## REMARKS

Reconsideration of the above-identified application is respectfully requested.

FIG. 7

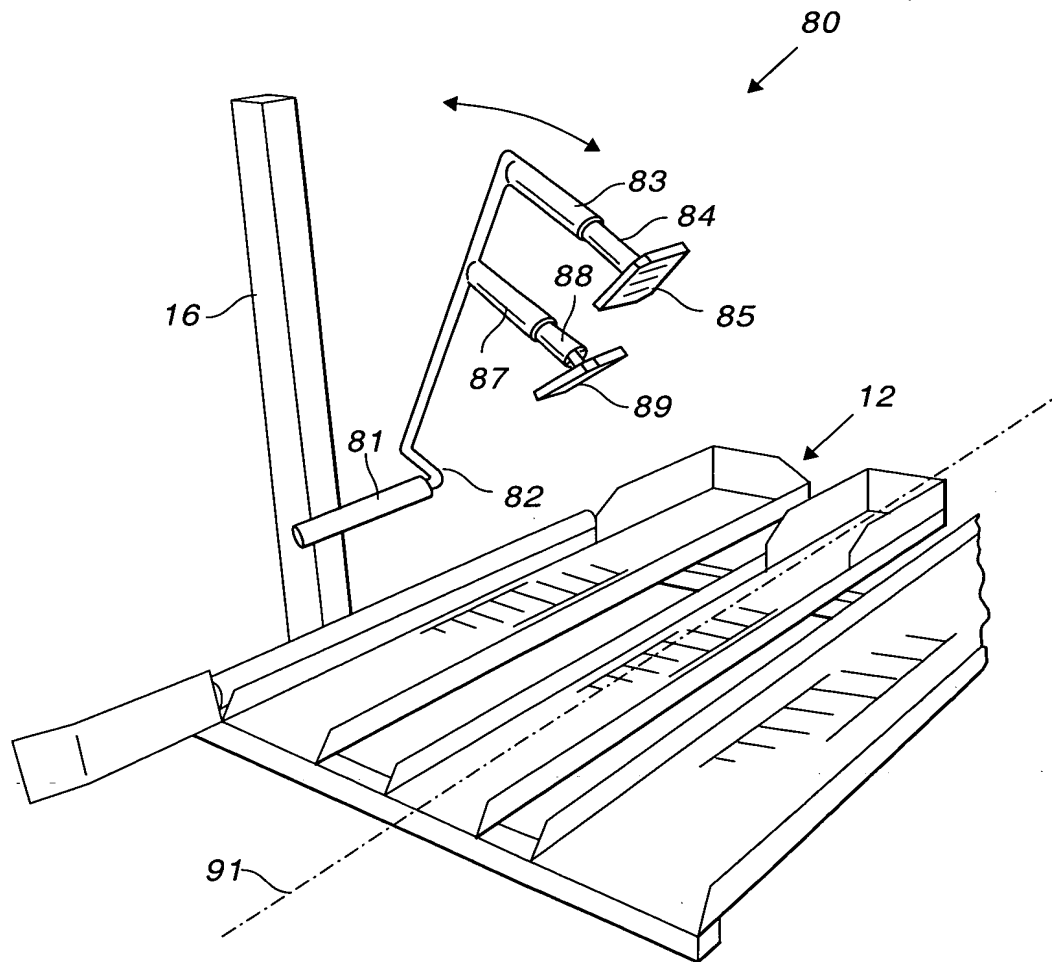
The drawings were objectionable for having duplicate reference numbers. A replacement sheet 4/4 is enclosed. Also enclosed is a copy of sheet 4/4 showing the changes in red. The description is changed to accommodate the changed reference numbers.
